| Product hierarchy no. * |     |      | Part no.   | SBU            | Type / Description | Customer part no. |
|-------------------------|-----|------|------------|----------------|--------------------|-------------------|
| 02                      | 007 | 013  | 0000002409 | See list below | Appliance outlet   | 5216              |

Modification of rating mark

| 5216 Appliance outlet |            |              |             |                  | 0118.2203 |        |

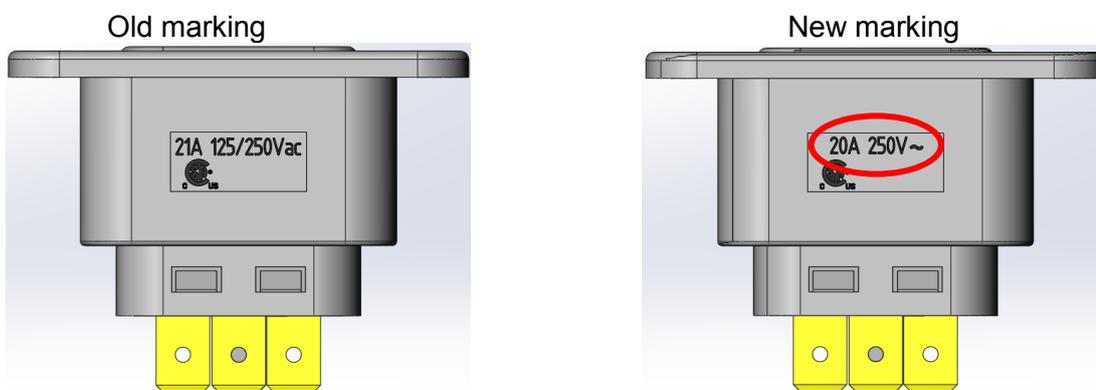
Change of rated current acc. to UL 60320

Rated current adjusted to UL 60320

Form: New current rating according to UL 60320  
Fit: N/A  
Function: N/A  
Production Site: N/A  
Product Label: N/A
